** AGC Mod by Peter Lankshear. 22/08/1984

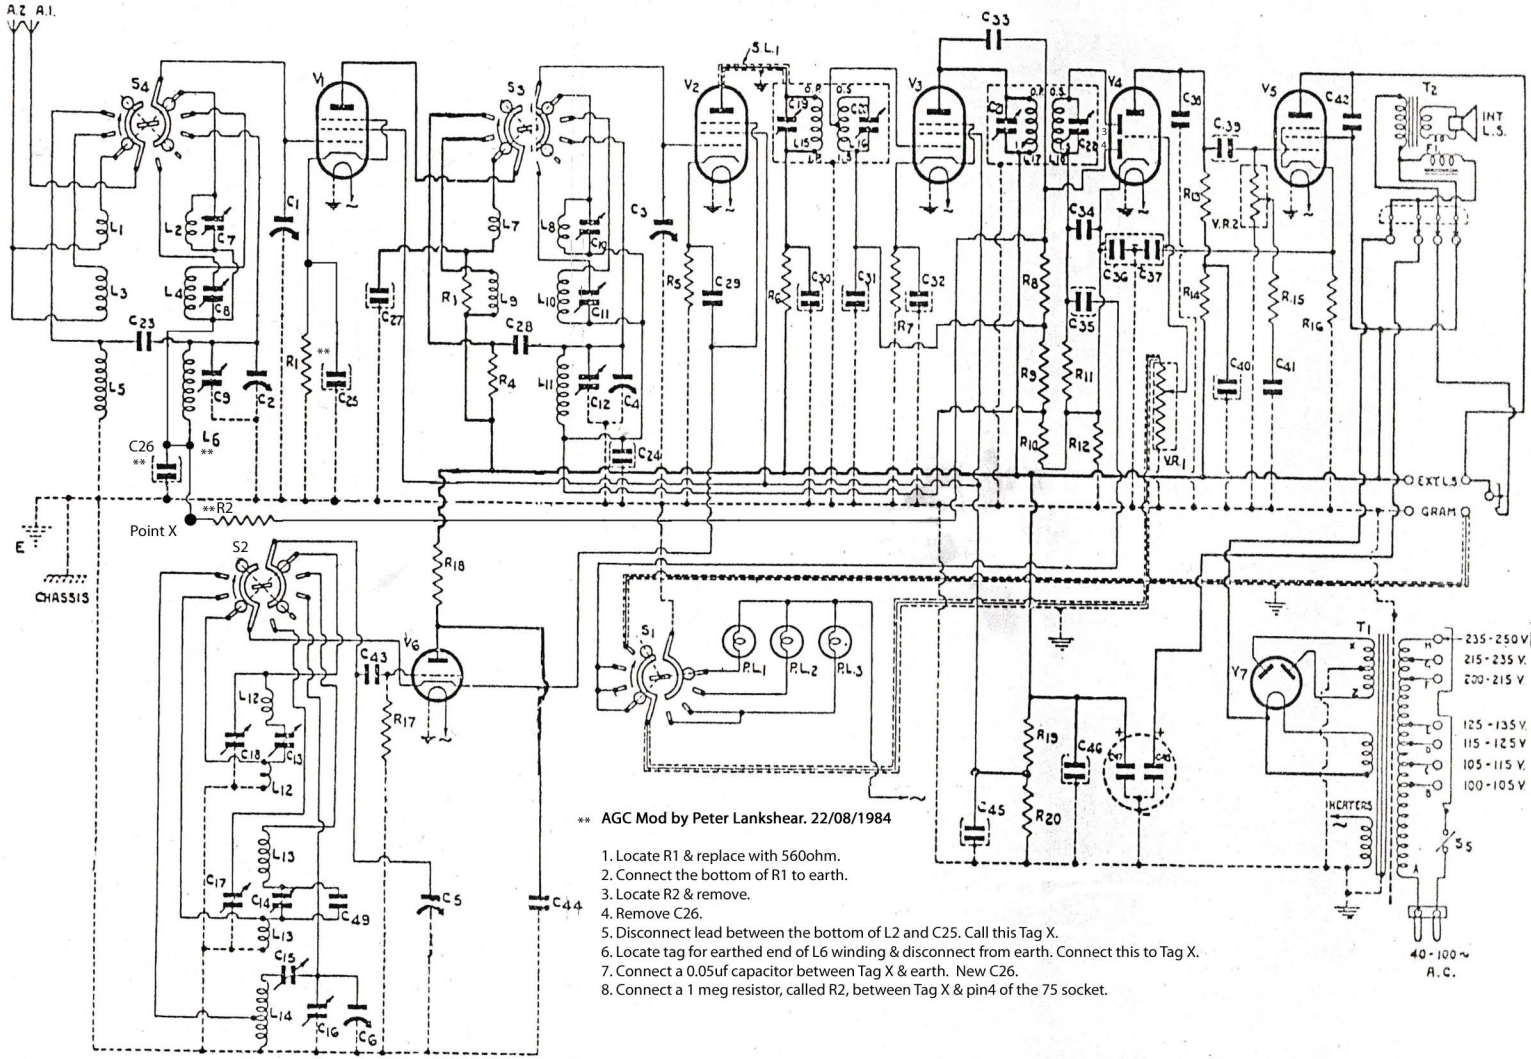
1. Locate R1 & replace with 560ohm.
2. Connect the bottom of R1 to earth.
3. Locate R2 & remove.
4. Remove C26.
5. Disconnect lead between the bottom of L2 and C25. Call this Tag X.
6. Locate tag for earthed end of L6 winding & disconnect from earth. Connect this to Tag X.
7. Connect a 0.05uf capacitor between Tag X & earth. New C26.
8. Connect a 1 meg resistor, called R2, between Tag X & pin4 of the 75 socket.
